RE: **“Other Business” Application No. 57 (2023)**  
**Agreeable Stipulations, Revised Site Plan and Additional Information**  
Applicant: Susan H. Pryor  
Subject Property: 275 Lane Dr. Mableton, GA 30126

SPR-2023-00317  
Lot Division and Retracement Survey for:  
**Susan H. Pryor and Bradley Q. Pryor**  
Land Lot 75  
18th District, 2nd Section  
City of Mableton  
Cobb County, Georgia

**ITEM OB-57-2023**

To consider a lot size reduction from 20,000 square-feet to 18,990 square-feet for Lot 2 for Susan H. Pryor for property located on the south side of Lane Drive in Land Lot 75 of the 18<sup>th</sup> District (275 Lane Drive).

SPR-2023-00317  
Lot Division and Retracement Survey for:  
**Susan H. Pryor and  
Bradley Q. Pryor**  
Land Lot 75  
18th District, 2nd Section  
City of Mableton  
Cobb County, Georgia

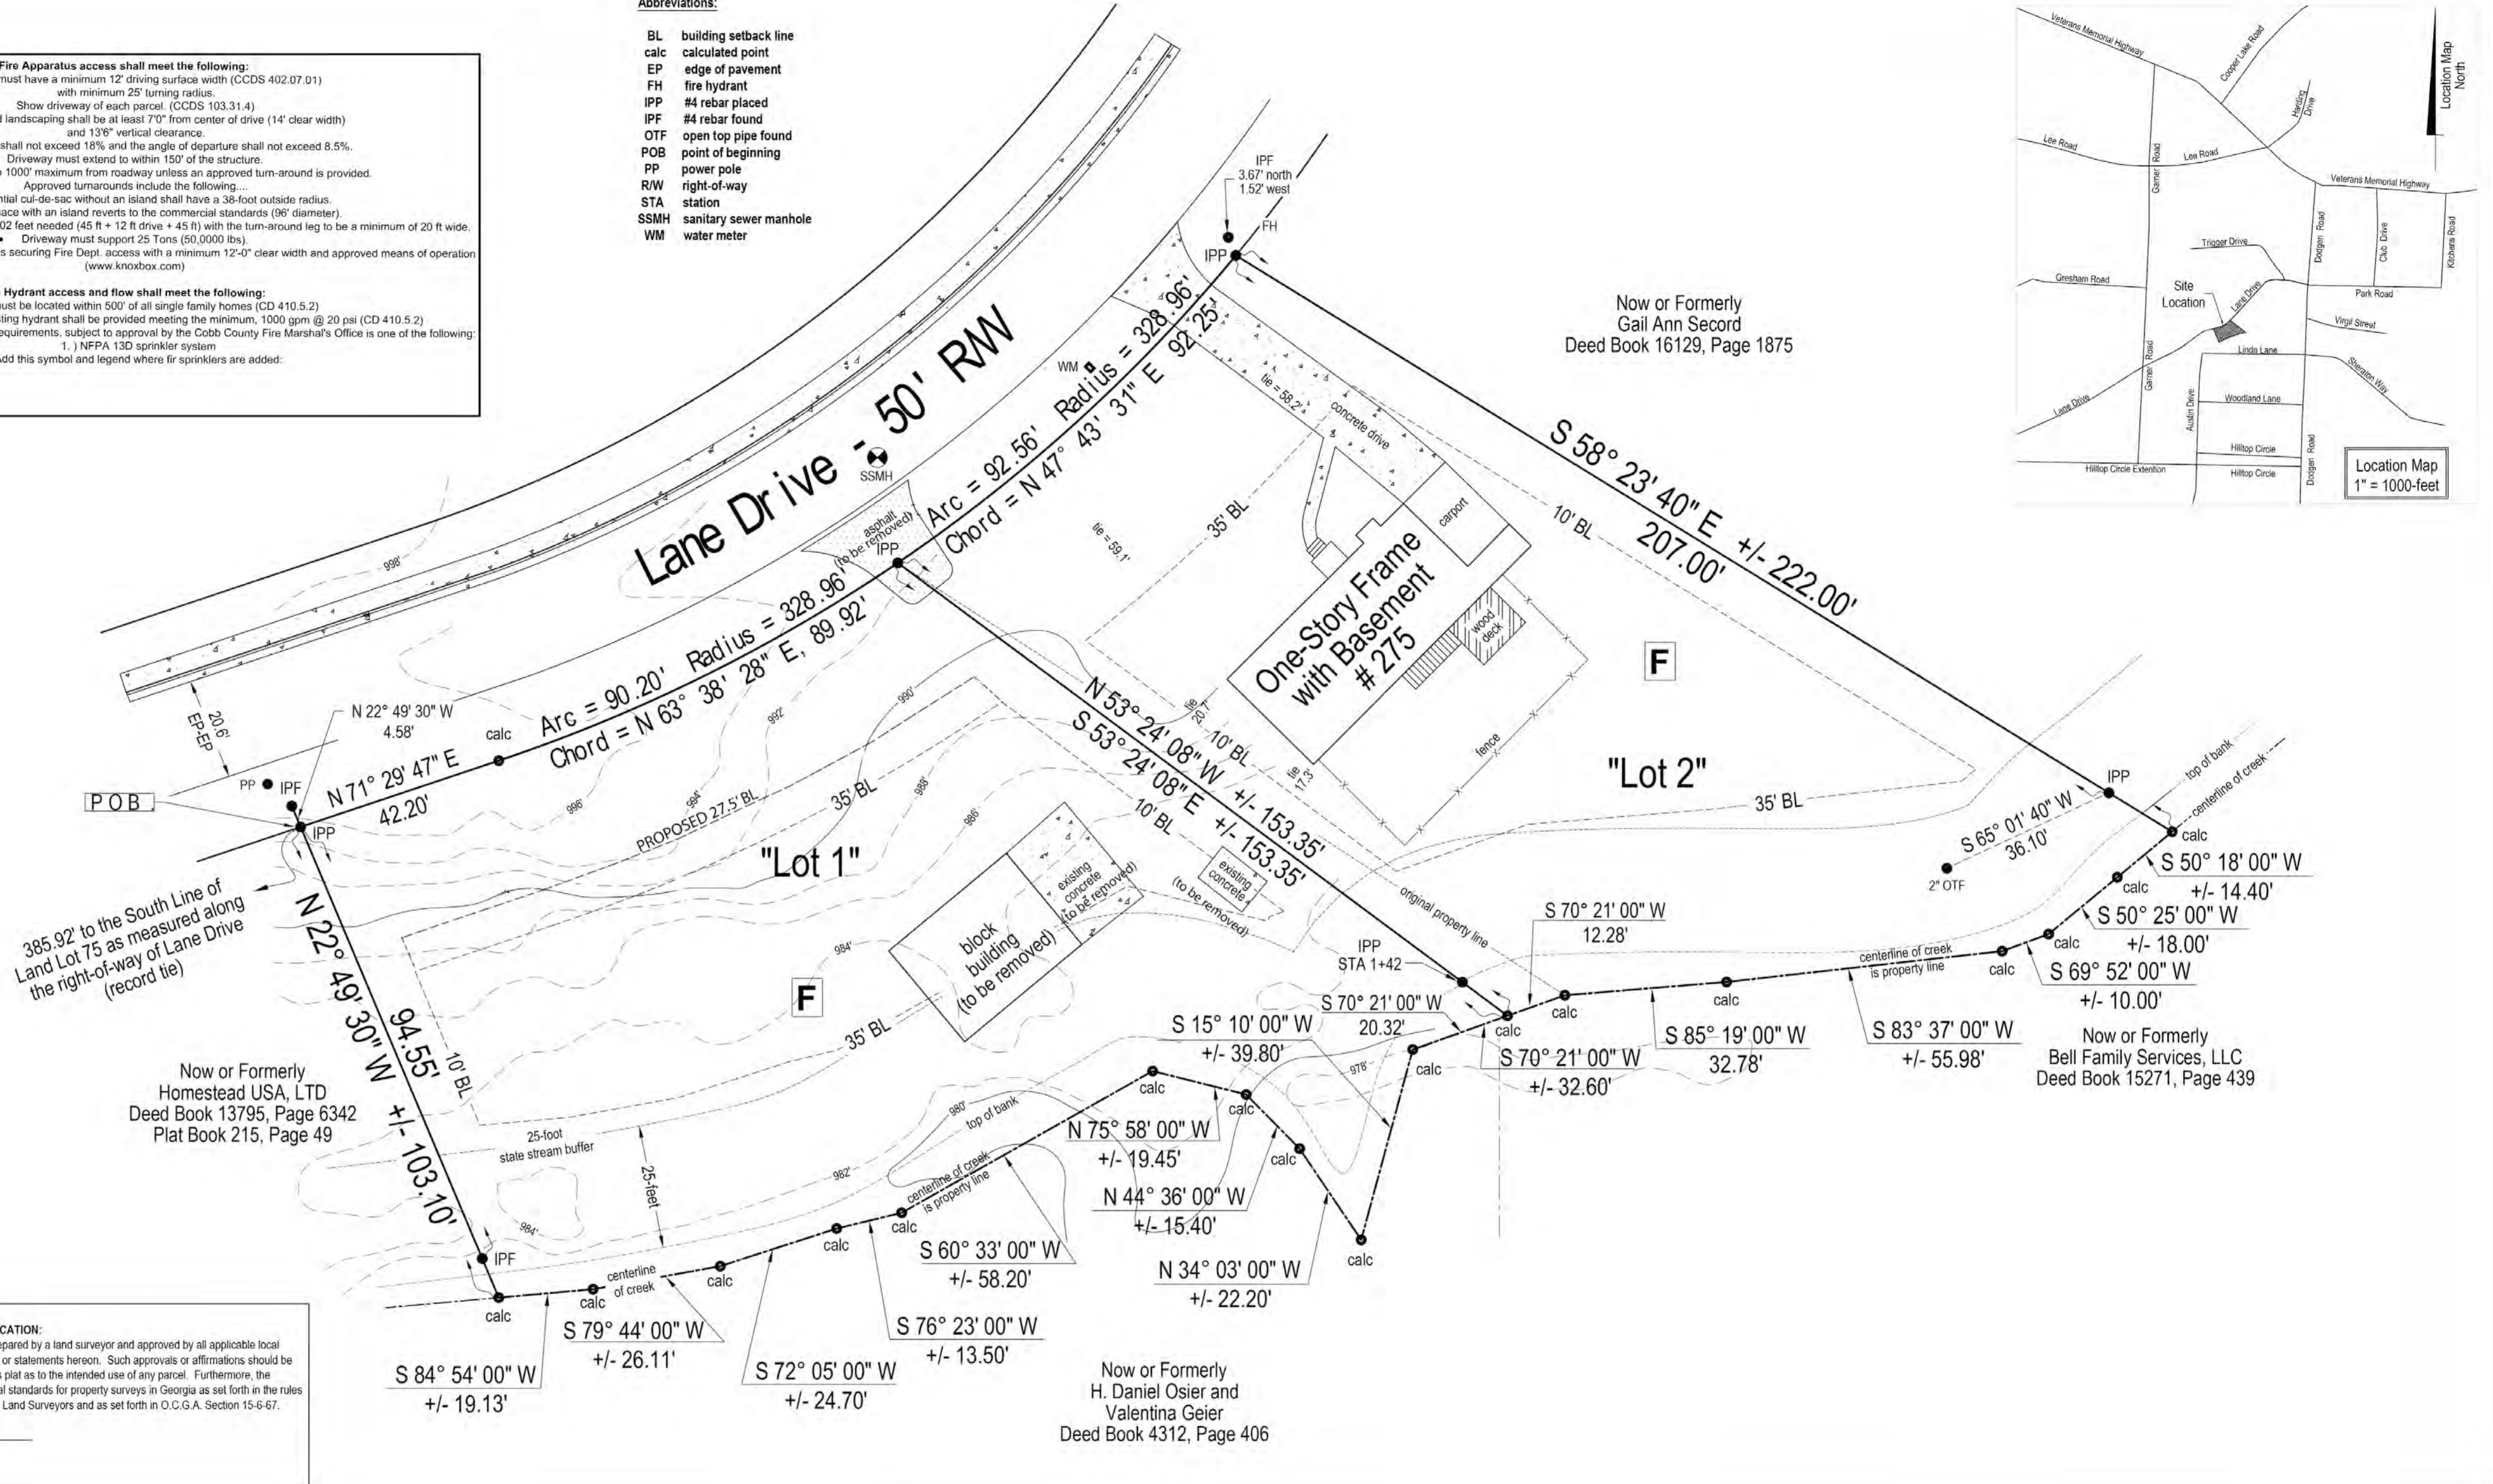
An updated Lot Division Plan dated October 3, 2023 is attached hereto and replaces the version submitted with the application. This version of the Lot Division Plan was developed as a result of conversations with County departmental staff and members of the Applicant's project team. Changes included in the revised Lot Division Plan are:

1. The proposed 27.5' front setback / building line is shown on Lot 1 as per the request in the Application,
2. The 50' and 75' stream buffers have been removed,
3. Additional existing structures on Lot 1 are labeled 'to be removed'

- 
- B. Compliance with the comments and recommendations of the Cobb County Department of Transportation (DOT) inclusive of the following:
1. Donation of land area for the purpose of right-of-way (ROW) on the south side of Lane Drive. The new ROW shall extend 25' from the center line of the existing roadway as currently shown on the revised Lot Division Plan dated October 3, 2023 and attached hereto.

HOUSE SITE PLAN STUDY 8.2.23

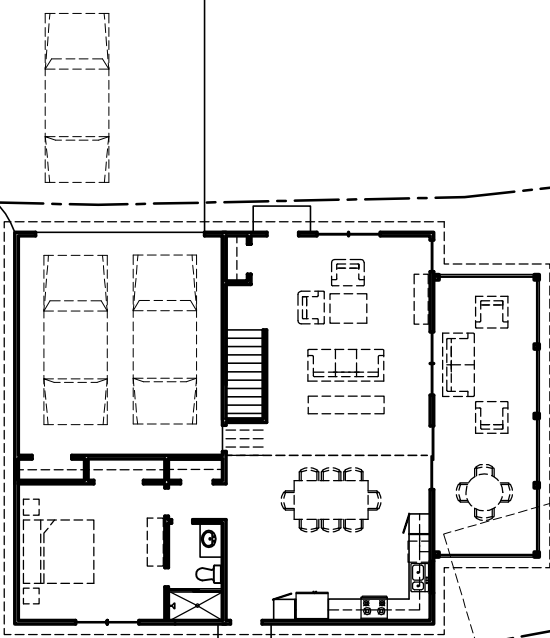
Additionally, a House Floor Plan Study produced by the project architect, Peter Polite, is attached and provided to further illustrate the concept for the dwelling to be constructed relative to site and regulatory conditions.
